Docket Item # 3
BAR CASE # 2010-0052

BAR Meeting
April 21, 2010

ISSUE: Alterations
APPLICANT: Santo & Beverly Polizzi
LOCATION: 817 S Columbus Street
ZONE: RM Residential

Figure 2. Site plan of proposed alterations.

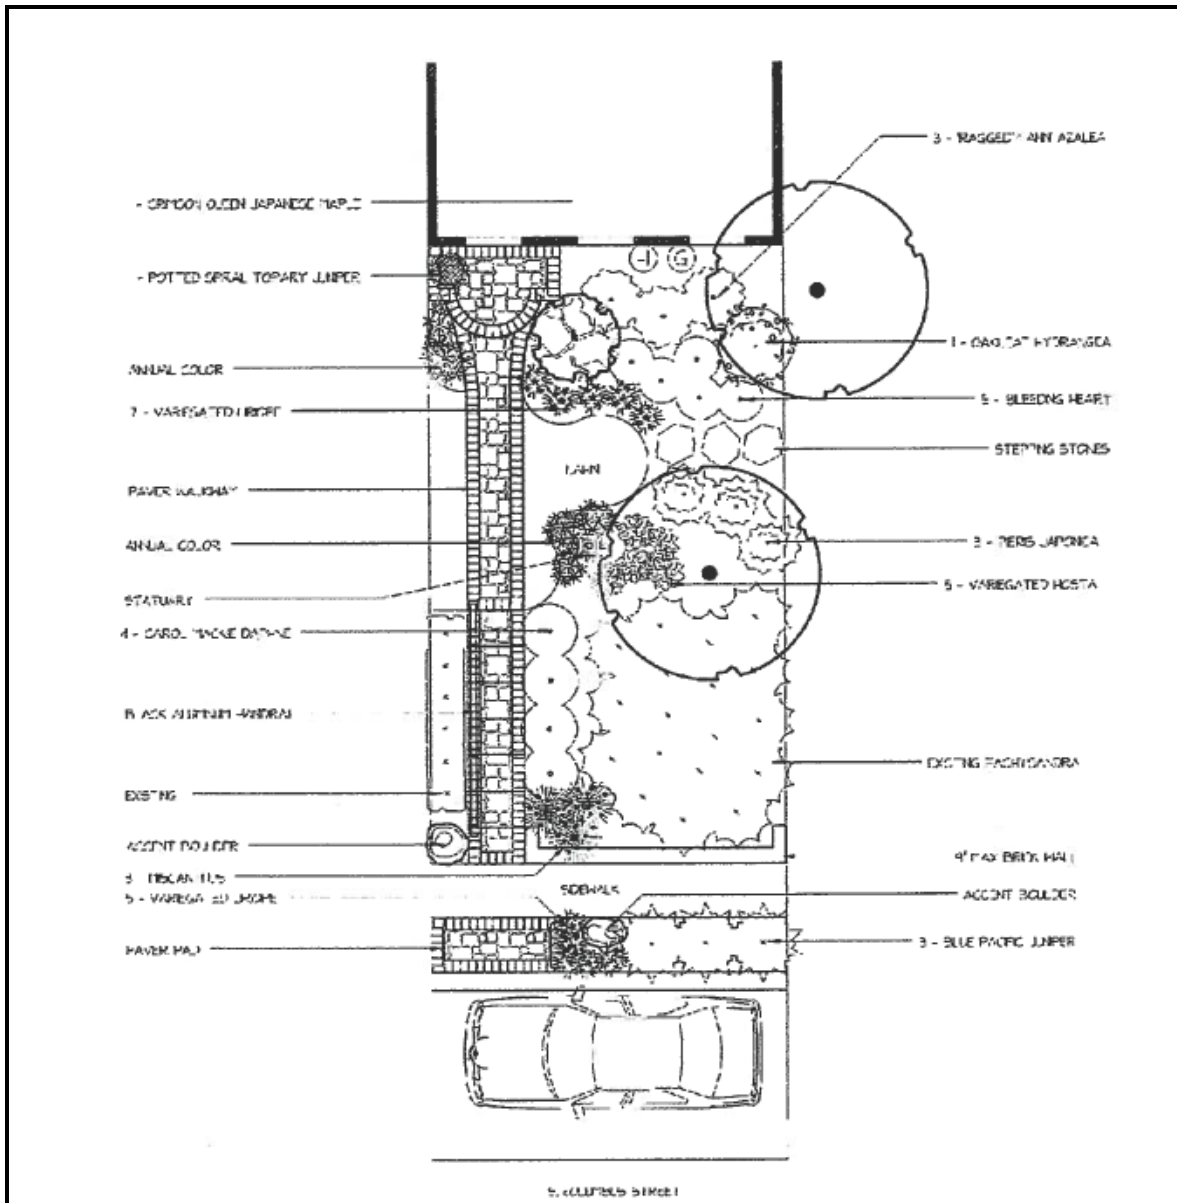
- R1. The building permit plans shall comply with requirements of City Code Section 8-1-22 regarding the location of downspouts, foundation drains and sump pumps. Refer to Memorandum to Industry dated June 18, 2004. [Memorandum is available online at the City web site under Transportation\Engineering and Design\Memos to Industry.]. A copy is also attached for the applicant's convenience. (T&ES)

- R2. Applicant shall be responsible for repairs to the adjacent city right-of-way if damaged during construction activity. (T&ES)
- R3. All improvements to the city right-of-way such as curbing, sidewalk, driveway aprons, etc. must be city standard design. (T&ES)

- R4. No permanent structure may be constructed over any existing private and/or public utility easements. It is the responsibility of the applicant to identify any and all existing easements on the plan. (T&ES)

STAFF RECOMMENDATION: Staff recommends approval of the Certificate of Appropriateness with the condition that the applicant modify drainage to comply with T&ES comments.
